SERVICE LETTER: #71

TITLE: AT-802 Inspection for Cracks

EFFECTIVITY: All AT-802 aircraft with Wipaire 10000 Floats installed.

Figure 1

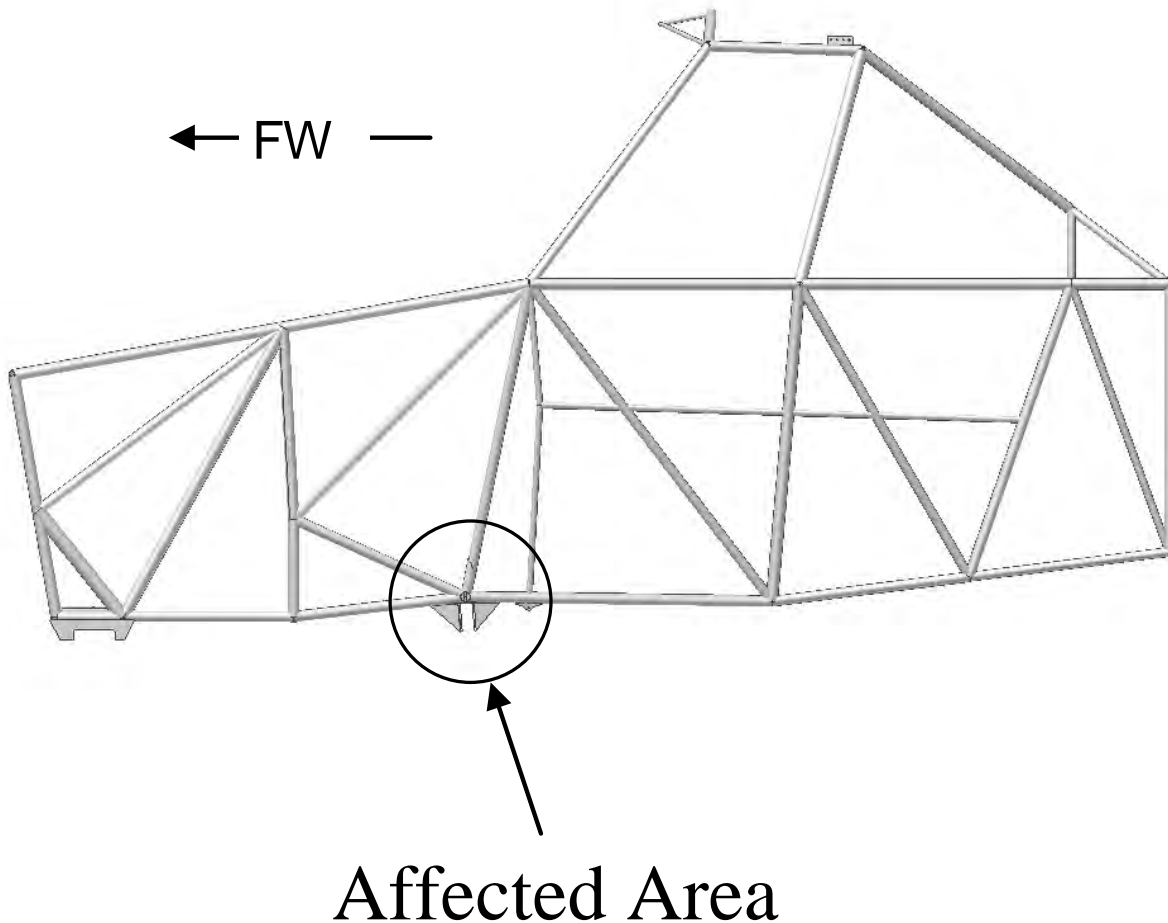
BACKGROUND INFORMATION: Cracks were found after pilot noticed linseed oil leaking from the float fitting at the top of the left-hand pylon, shown in Fig. 1. The cracks were located on the weld, shown in Fig. 2, area D. Further investigation revealed other aircraft with similar cracks either in the same place or on the welds of the attach plate (Fig.3, items 2&3), shown in Fig. 2, area B and C. The cracks are believed to be caused by the welding process and aggravated by normal operations.

METHOD OF COMPLIANCE: Visually inspect lower longeron tube (Fig. 1) and the entire nearby welded tube cluster for signs of cracking on both sides of the aircraft. Pay special attention to areas A, B, C, and D on Fig. 2. If there is doubt about crack presence, strip paint from tubes for better visibility and consider dye penetrant or eddy current inspection. This service letter requires all aircraft to modify the gussets as shown in Fig. 3, Items 1 and 4 to match included drawings p/n 10A02491-006 and 10A02491-005 to alleviate the stress on the longeron tube without regard to crack presence. Figure 5 shows completed gusset modification. If cracks are found, their size and location will determine further action required.

Figure 2

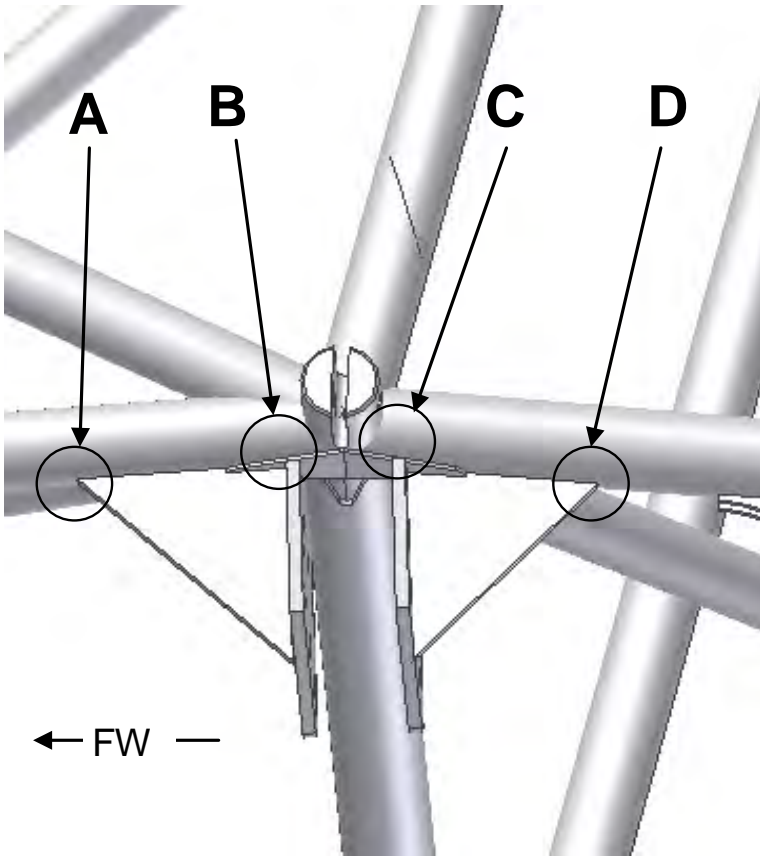
If cracks are found in areas B and C in Fig. 2, and they are smaller than 5/16 inch, and they do not depart the bead of the weld continue inspections on known cracks in locations B and C for growth every 25 hours until the aircraft is in for major repair. At that time, grind off the extended edge of the attach plates (Fig. 4, area 1) so that the doubler (Fig. 4, Item 4) is exposed enough to continue weld across the outboard edge and back inboard in between attach plates (Fig. 4, Items 2 and 3) at least ¼ to ½ inch. If cracks grow larger than 5/16 inch or depart the weld, perform repairs as specified above as soon as practical. Gussets must also be modified as stated earlier in this service letter. Inspect repair every 100 hours.

If there are cracks at the end of the rear gusset (Fig. 2, area D) and they are no longer than 5/16 inch and do not depart the bead of the weld around the edge of the gusset, modify the gussets as stated above, grind out the cracks and fill with weld. Continue visual inspections every 100 hours.

If crack has progressed further than the edge of the weld (Fig. 2, area D) or the front gusset welds are cracked at all (Fig. 2, area A) consult Wipaire Engineering Department immediately for further instructions. A service kit will be issued promptly for these cases.

If no cracks are found, modify both gussets as described above and return to normal operations. Inspect joint for crack presence located at Fig. 2, areas A, B, C and D at 100 hour intervals.

9. Strip paint in all areas requiring welding or stress relieving.
10. Fill fuel tanks.
11. Groove out cracks (Fig. 2, area D) and re-weld.
12. If cracks are found on the ends of the attach plates (Fig. 4, area 4), cut the attach plates back to a location over the bottom doubler on the cluster (Fig. 4, areas 1 & 4). Re-weld attach plates to the doubler and wrap the weld around the inside $\frac{1}{4}$ to $\frac{1}{2}$ inch.

Figure 5

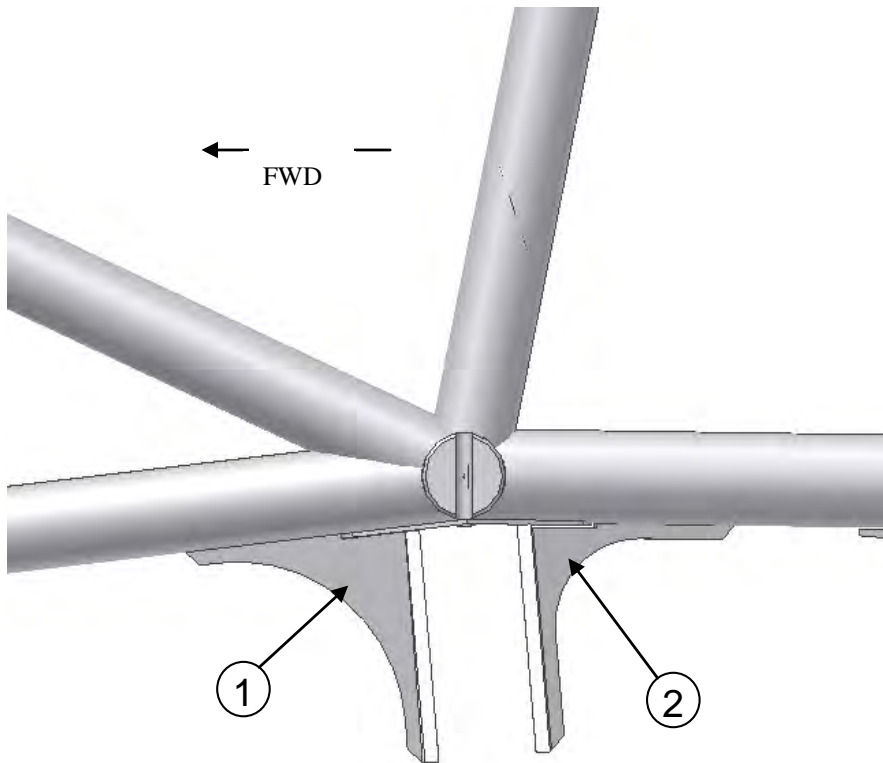
1. This airframe can be modified without removing the floats.
2. Drain fuel.
3. Remove fairings and fuel selector valve.
4. The sheet metal on the forward side can be cut away as required and a cover screwed on when complete.
5. Reshape aft Gusset by grinding out as shown in Fig. 5 using drawing p/n 10A02491-006 as a pattern.
6. The aft gusset can be cut from the top side without removing the bottom fairing or cutting any sheet metal away.
7. Reshape front gusset as shown in Fig. 5 using drawing p/n 10A02491-005 as a pattern.
8. Rough cut with abrasive wheel. Finish with carbide burrs. A 90 Degree angled high speed grinder and a straight high seed grinder will be required.
9. Clean prime and paint areas where paint is missing, chipped or damaged.

7. Cut openings in fairings and fabricate new screw-on covers.
8. Remove Aluminum float attachment block.
8. Reshape both front and rear gussets as shown in Fig. 5 using drawings p/n 10A02491-006 and 10A02491-005 as a pattern.
